Planning and Zoning Board

CASE NUMBER: Z17-002 (PLN2016-00885)
LOCATION/ADDRESS: The 6400 through 6600 blocks of South Mountain Road (west side) and the 6400 through 6600 blocks of the South Signal Butte Road alignment (east side).
GENERAL VICINITY: Located west of Mountain Road and north of Pecos Road.
REQUEST: Rezone from AG to HI-PAD AF (20± acres); and rezone from GI-CUP AF to HI-PAD AF (24.3± acres); and rezone from HI-AF to HI-PAD AF (5.82± acres); and Site Plan Review.
PURPOSE: This request will allow for the expansion of an industrial facility.
COUNCIL DISTRICT: District 6
OWNER: Signal Butte 20 LLC, owner.
APPLICANT: Reese Anderson, Pew and Lake PLC
STAFF PLANNER: Wahid Alam, AICP-Planner II

STAFF RECOMMENDATION: Approval with Conditions

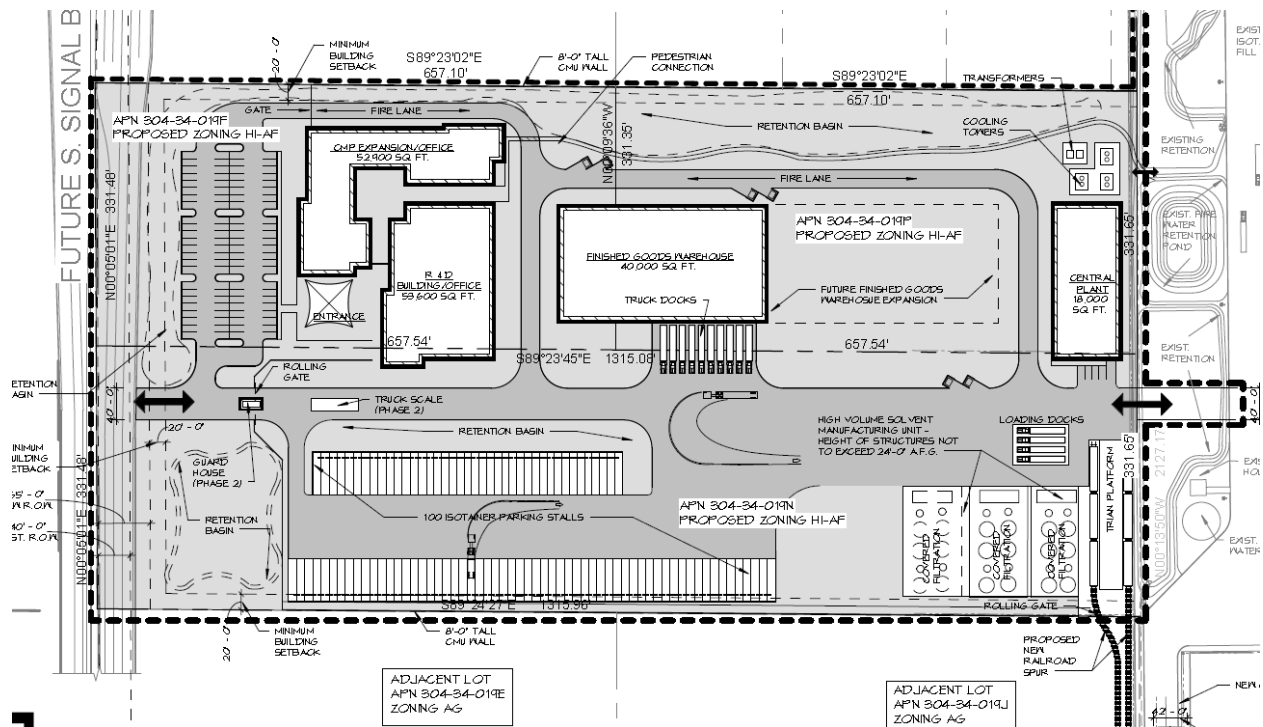
The proposed Isotainer expansion area north of the existing facility and the Phase 1 site plan for a portion of the 20-acre expansion is shown in the figure above. Until Signal Butte Road is constructed, the proposed development will use the existing Pecos Road and Mountain Road for access for its daily operation. The items included in this site plan are:

- 1) Central Plant Building for 18,000 square feet, including cooling towers and transformers;
- 2) High Volume Solvent Manufacturing Unit; and
- 3) Isotainer storage/parking area both on the expansion area and in the area along the north property line of the existing operation.

Staff has no concerns with the site plan as proposed. There are, however, a couple of site issues that do need to be resolved with this development.

One issue relates to development of the street network. Normally, the City codes require the immediate dedication and improvement of the adjacent section line road, Signal Butte in this case. However, none of this street exists in this area. Plus, with the planned expansion of State Route 24, at least some of the Signal Butte right-of-way will be part of the ADOT right-of-way. Because of these issues the City would prefer to delay the dedication of this right-of-way and construction of the roadway until an appropriate time in the future when the final right-of-way needs are determined and there is a need to build more of the roadway. The details and timing of this are to be worked out in a Development Agreement to be approved by Council prior to the approval of the rezoning (see conditions #9 and 12).

The final issue is the provision of water and sewer service to the west expansion area. The applicant has provided a letter describing how these services can be provided. The information provided is preliminary but demonstrates their understanding of the situation and commitment to providing the needed service even if it means extending new service lines in their private drive from Pecos (see conditions #9 and 10).

8. Replacing the proposed chain link fencing with a permanent wall consistent in design with the wall proposed for the south property line either with the development of Phase 2 of the expansion area or the construction of Signal Butte Road, whichever occurs first.

9. Execution of a Development Agreement to address issues such as:
 - a. Timing of payment of cash in lieu for Signal Butte Road;
 - b. Extension of water, sewer, and other utilities in Signal Butte Road;

- c. Potential access road to provide ingress/egress to adjacent properties north of the 20-acre expansion area east of Signal Butte Road, and;
 - d. Other related items.

12. Dedicate right-of-way on Signal Butte Road to achieve a 65-foot half-street from the monument line at the earlier of:
 - a. When requested by the City of Mesa;
